DRAWING INDEX			
SHT. #	DRAWING TITLE	REV. #	REV. DATE
C1	COVER SHEET		
F1	PRECAST NEXT BEAM LAYOUT		
F2	CURTAIN WALL ELEVATIONS		
NB1	PRESTRESSED NEXT BEAM DETAILS		
NB1.1	PRECAST CURTAIN WALL DETAILS		
NB2	PRESTRESSED NEXT BEAM DETAILS "CR-NB1"		
NB2.1	PRESTRESSED NEXT BEAM DETAILS "CR-NB1"		
NB2.2	PRECAST CURTAIN WALL DETAILS "CR-NB1"		
NB3	PRESTRESSED NEXT BEAM DETAILS "CR-NB2"		
NB3.1	PRESTRESSED NEXT BEAM DETAILS "CR-NB2"		
NB3.2	PRECAST CURTAIN WALL DETAILS "CR-NB2"		
NB4	PRESTRESSED NEXT BEAM DETAILS "CR-NB3"		
NB4.1	PRESTRESSED NEXT BEAM DETAILS "CR-NB3"		
NB4.2	PRECAST CURTAIN WALL DETAILS "CR-NB3"		
M1	MATERIALS LIST FOR NEXT BEAMS

J.P. CARRARA & SONS INC. Precast & Prestress Manufacturer 2464 OISE ST., MIDDLEBURY, VERMONT 05753 Phone:(802)388-6361 Fax:(802)388-9010	AUSTIN CONSTRUCTION, INC. CONTRACTOR CONCORD, VERMONT	
	STATE OF VERMONT AGENCY OF TRANSPORTATION COUNTY OF ORANGE	DATE: FEB. 11, 2015 SCALE: NOTED
TOWN OF CORINTH CHICKEN FARM ROAD T.H.16 CLASS 3 LOCAL ROAD BRIDGE NO.: 36 PROJECT NO.: BRO 1447 (29)	CHKD: RM DFTM: PSS JOB NO: 23448-014	
COVER SHEET		DWG. NO: C1

1 CURTAIN WALL ELEVATION - ABUTMENT #1
F2 (MARK END) 3/8" = 1'-0"

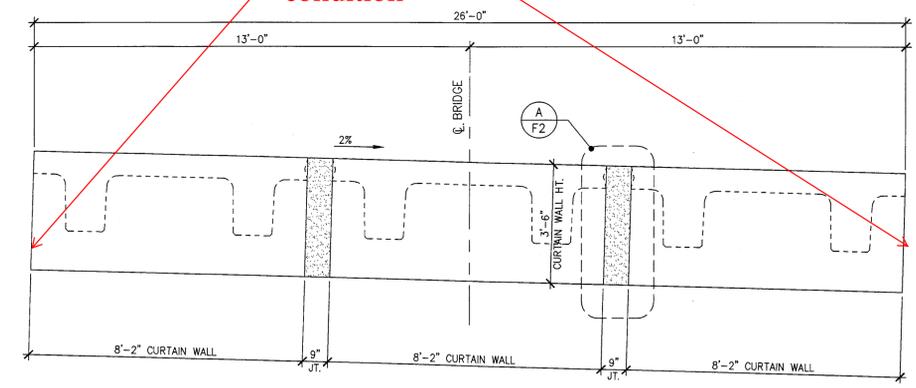
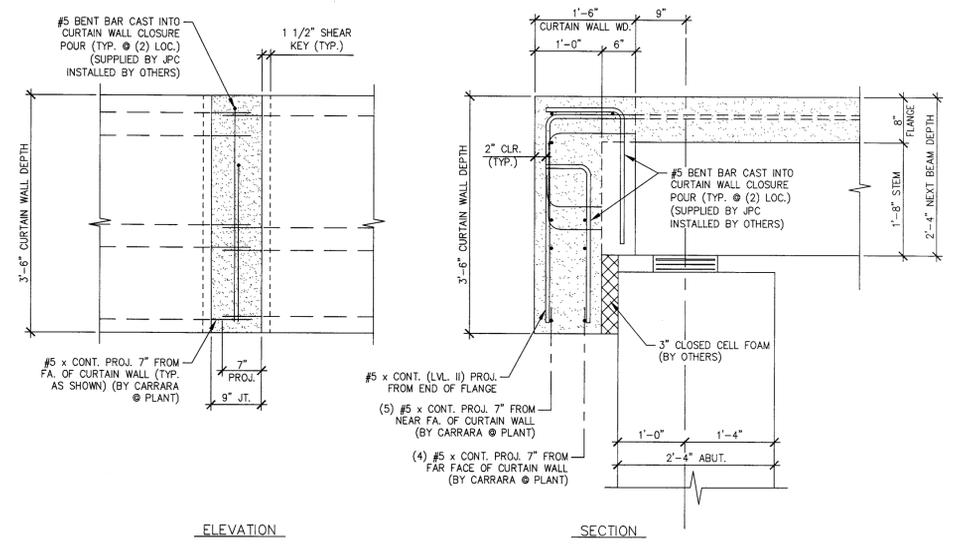
Outside edges must be plumb in final condition

G ADDITIONAL TRANSVERSE REINFORCING (@ BOTTOM OF FLANGE) & LOCATION OF PVC SLEEVES (@ STEM)
 NB1 3/4" = 1'-0"

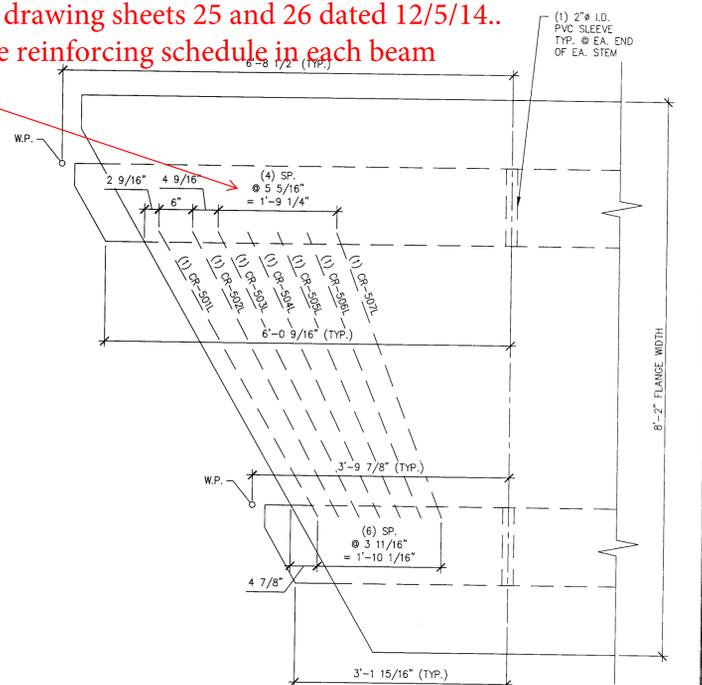
Need 20 spaces @ 6" for additional transverse reinf. at each beam end per revised drawing sheets 25 and 26 dated 12/5/14. This will change reinforcing schedule in each beam

A PROJECTING STRAND & PROJECTING BAR BEND DETAIL
NB1.1 3/4" = 1'-0"

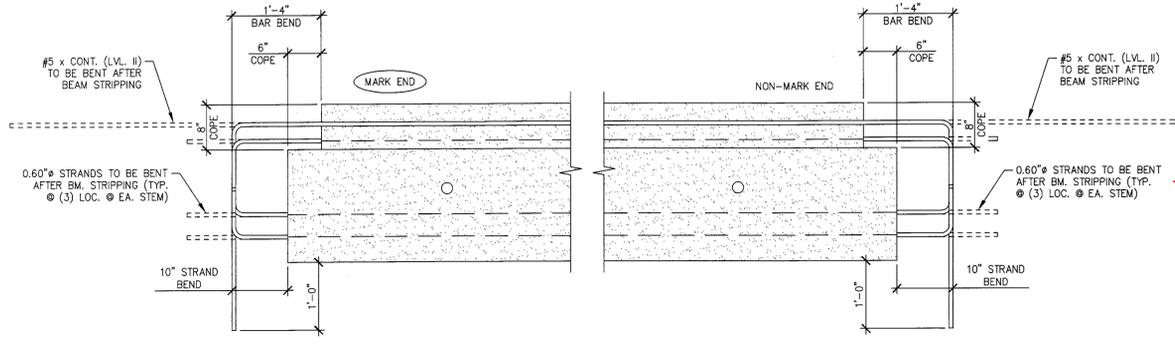
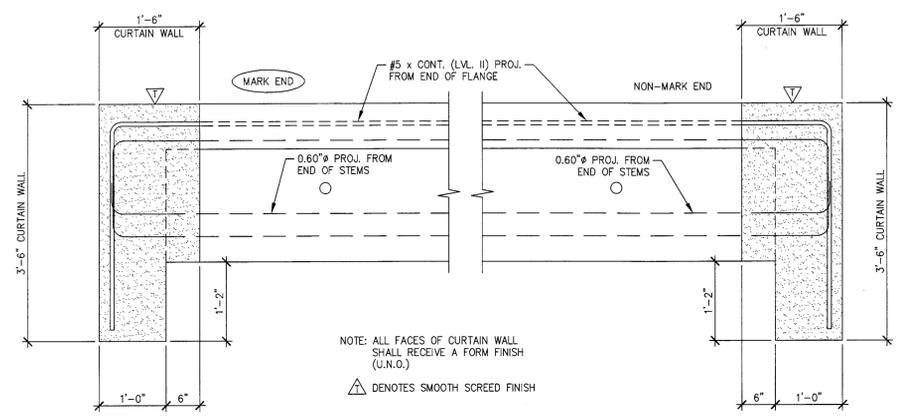
How will strands be bent? Pipe section s left in place will not be acceptable

1 CURTAIN WALL DIMENSIONAL ELEVATION
NB4.2 VOL.: 1.54 cy WT.: 3.12 T 3/4" = 1'-0"

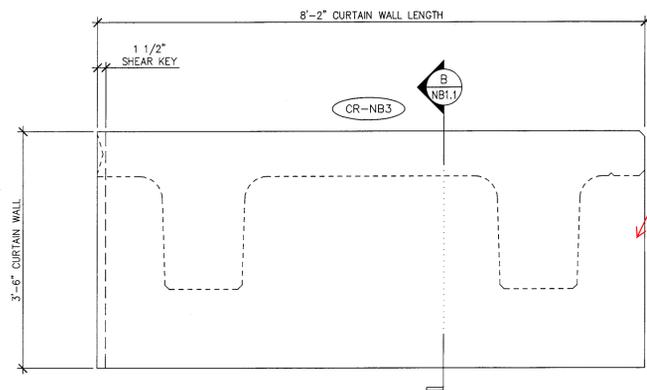
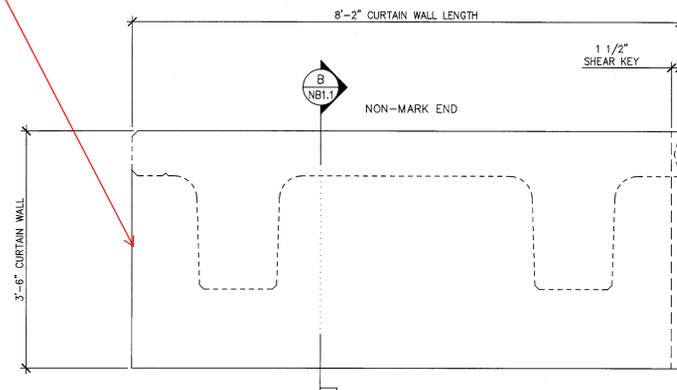
Exterior edges of curtain walls must be plumb in final condition
